STAFF REPORT TO THE PLANNING COMMISSION FOR PRELIMINARY PLAT REQUEST

The layout of the Preliminary Plat of Hidden Lake West Phase 1, P.P. # 70-14-18-100-001, located at 7900 48th Ave, zoned Low Density Residential (LDR), Georgetown Township, Ottawa County, Michigan.

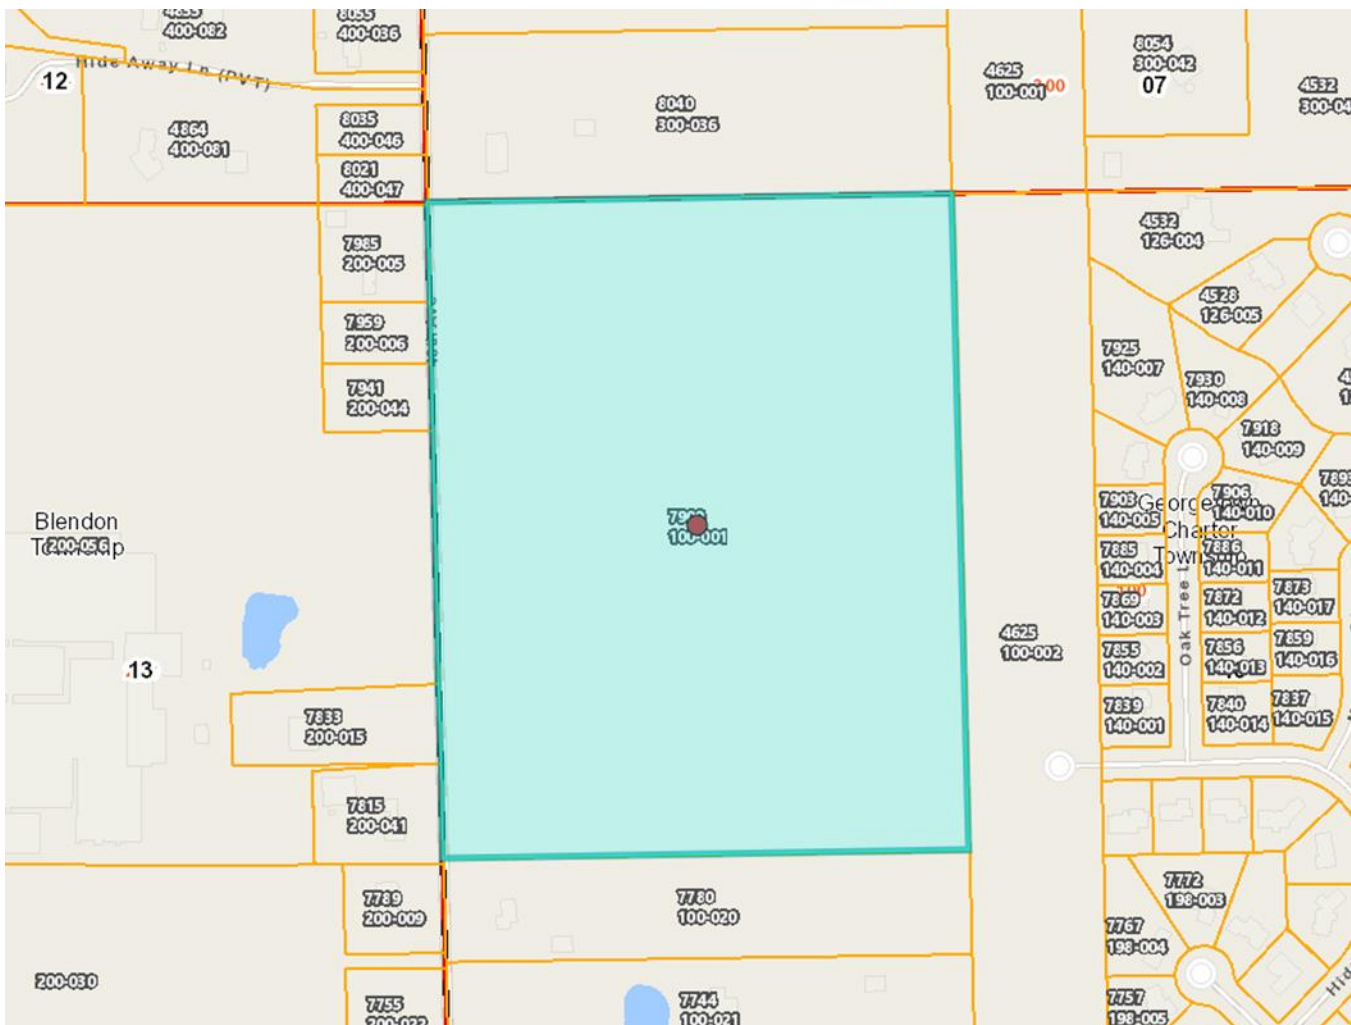
- a. The lots and building envelopes appear to meet ordinance requirements (all will be reviewed for exactness at the time a building permit application is submitted).

- a. Lots 45 and 46 have rear yards affected by a 30’ drainage easement (45 and 46 will be in Phase 2).
 - b. Lots 10 through 18 (double frontage lots) are affected by a 20’ drainage easement in the yard fronting 48th Ave.

- c. Lots 2, 3, 6, 7, and 9 have rear yards affected by a 20’ drainage easement.
 - d. The waterfront lots on Hidden Lake West have rear yards affected by a 20’ drainage easement. These are situations noted to be created by the developer and would be considered to be a **self-created situation in case any variance requests are submitted in the future based on those circumstances.**

- b. **If there will be a plat entry sign, a legal instrument detailing responsibility for ownership and maintenance shall be provided at the time a sign permit application is submitted.**

- c. **As per the applicant, all drainage easements and detention areas will be conveyed to the Ottawa County Water Resources Commission.**
- d. Attached garages with a minimum of 400 square feet shall be provided.

- e. There shall be a deed restriction on the lots (10 through 18, 20, and 21) that have frontage on 48th Ave that will prohibit driveway access to 48th Ave as per the Master Plan and the North-South Corridor Study from May 2004. Page 44 of the Master Plan states that the future plan is to widen 48th Ave to five lanes from the southern border of Georgetown Township to Bauer Road. The North-South Corridor Study recommends 48th Ave to be developed as a “partially controlled facility”, which means access may only be permitted via public roads and that no private driveways are allowed.
- f. Plat restrictions will require that individual lots with frontage on 48th Ave are required to maintain the adjacent sidewalk and parkway area.

- a) Building envelopes appear to meet ordinance requirements, but will be reviewed for exactness at the time a building permit application is submitted. Lots 45 and 46 (Phase 2) have rear yards affected by a 30’ drainage easement, lots 10 through 18 (double frontage lots) are affected by a 20’ drainage easement in the yard fronting 48th Ave, lots 2, 3, 6, 7, and 9 have rear yards affected by a 20’ drainage easement, and the waterfront lots on Hidden Lake West have rear yards affected by a 20’ drainage easement. These are situations noted to be created by the developer and would be considered to be a **self-created situation in case any variance requests are submitted in the future based on those circumstances.**

- b) All fees, including deferred assessments, shall be paid prior to the issuance of any building permits.
- c) If there is to be a plat entry sign, some type of legal instrument must be submitted for the maintenance of the sign at the time an application is submitted for a sign permit.

- d) Attached garages with a minimum of 400 square feet shall be provided.
- e) Sidewalks will be provided by the individual property owner at the time a house is constructed.

- f) There shall be a deed restriction on the lots (10 through 18, 20, and 21) that have frontage on 48th Ave that will prohibit driveway access to 48th Ave.

- g) Plat restrictions will require that individual lots with frontage on 48th Ave are required to maintain the adjacent sidewalk and parkway area.
